SUBJECT: CATAWBA NUCLEAR STATION, UNIT 2 RE: DRAFT SAFETY EVALUATION
FOR A PROPOSED AMENDMENT (TAC NO. MB1498)

The proposed amendment would revise the cold leg elbow tap flow coefficients used in the determination of Reactor Coolant System flow rate. Please review the technical accuracy of the information discussed in the enclosed draft Safety Evaluation and let us know if you find any inconsistencies as soon as possible. There are no changes to the Technical Specifications associated with this proposed amendment.

SAFETY EVALUATION BY THE OFFICE OF NUCLEAR REACTOR REGULATION
RELATED TO AMENDMENT NO. _____ TO FACILITY OPERATING LICENSE NPF-52

CATAWBA NUCLEAR STATION, UNIT 2

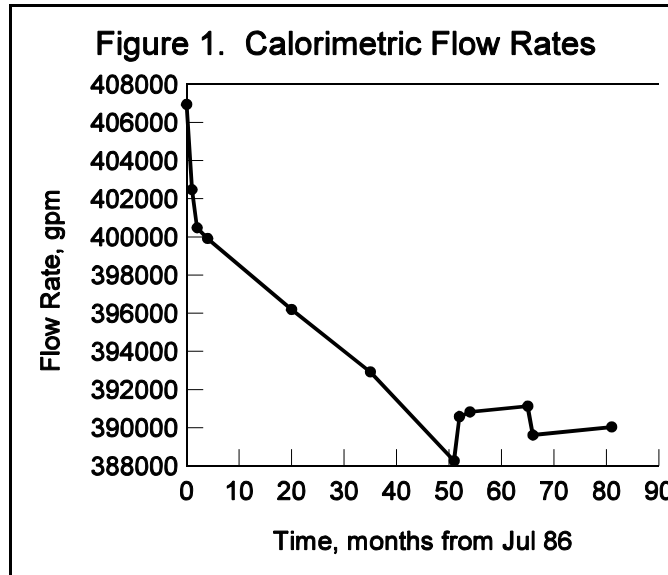
The calorimetric-determined flow rate values from Table 1 are plotted in Figure 1. The licensee excluded the July 1986 value because it was based on data obtained at 75 percent power (Reference 6), in contrast to the remaining values based on 98 percent or greater power. It used the remaining 11 values to establish its approved elbow coefficients. It proposes using the September and November 1986, and March 1988 values to establish elbow coefficients. The licensee believes the September 1986 and November 1986 values have less thermal streaming in contrast to the March 1988 value, which the licensee states "... contains a

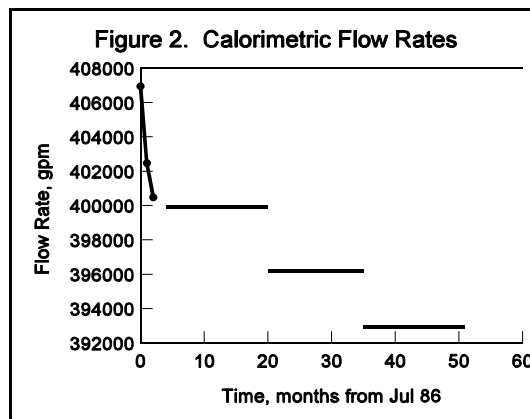
To assess these statements and their implications, we first assume the initial flow rate degradation is due to RCP impeller smoothing, as discussed in Section 3.2, below. Then we assume the later degradations are essentially due to physical changes during refueling outages and flow rate is essentially unchanged between outages. (This assumption is consistent with observed behavior.) This results in the Figure 2 representation of the early values.

licensee's model predicts this has little effect on RCS flow rate, which substantiates our judgement that SG tube plugging has little influence on flow rate during the first few months of operation. Since SG tube plugging does not significantly affect the flow behavior illustrated in Figure 2, we conclude that the apparent step flow rate decrease of 3700 gpm at 20 months is due to a combination of core reload and RTD bypass removal.

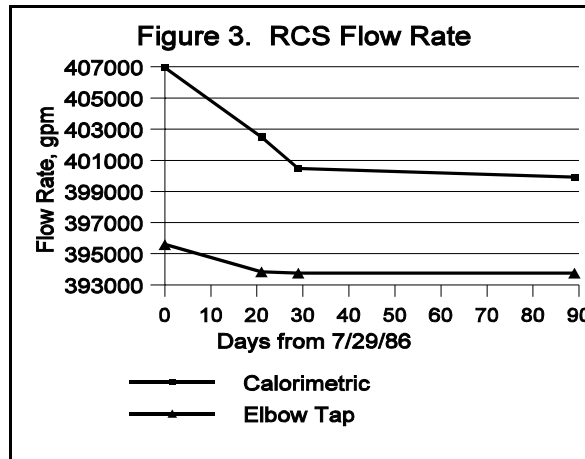
Consider the flow rate degradation illustrated in Figure 3, which provides the early calorimetric values and elbow predictions.³ The calorimetric values reflect the downward trend illustrated in Figure 1, but the elbow values are constant after the initial value. (We are interested in the trend in elbow values, not the values for purposes of this discussion since the elbow information results from coefficients obtained using 11 calorimetrics.) Neglecting potential error due to uncertainty in the values and a bias due to using 11 calorimetrics, the change in elbow value during the first 21 days of operation is about 1750 gpm, a change we believe is due to RCP impeller smoothing, as identified in Section 2, above. Further, the elbow information implies there was little smoothing after 21 days. Since some impeller smoothing will have occurred before the Figure 3 information was obtained, on this basis the total smoothing effect will be greater than 1750 gpm.

Although the first calorimetric was made at 75 percent power, we note the trend is consistent with the second and third values and there is little inconsistency between the calorimetric and elbow trends, although the magnitudes are different. If we assume the calorimetric values are correct, then the flow rate decreases by 6500 gpm during the first month and, consistent with the calorimetric, is relatively constant during the next few months.

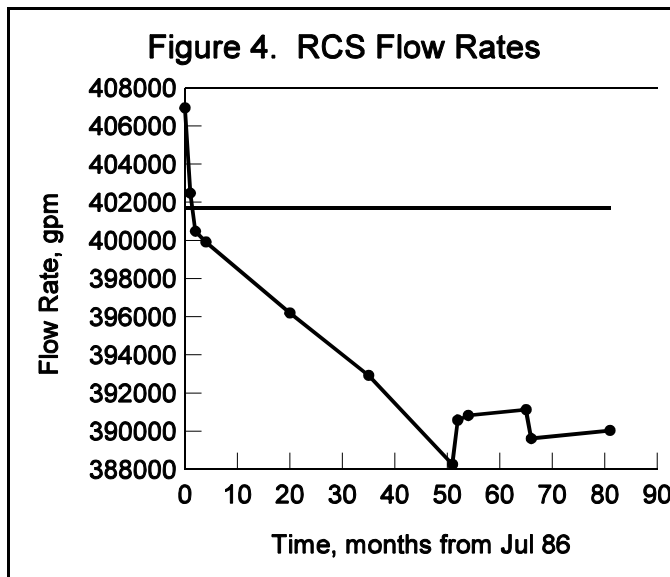
As illustrated in Figure 4 (References 2 and 5), the analytic model predicts an essentially constant RCS flow rate of ~401,700 gpm during the first few years of operation in contrast to the calorimetric determinations, which show significant variation.

There were 80 SG tubes plugged early in plant operation. The licensee's model predicts this has little effect on RCS flow rate, a reasonable prediction. However, the licensee did not address modeling changes associated with RTD bypass removal, and its model results do not reproduce the flow rate increase illustrated by the elbow response following manifold removal and as-expected from that removal. The licensee should ensure the model correctly represents these flow perturbations.
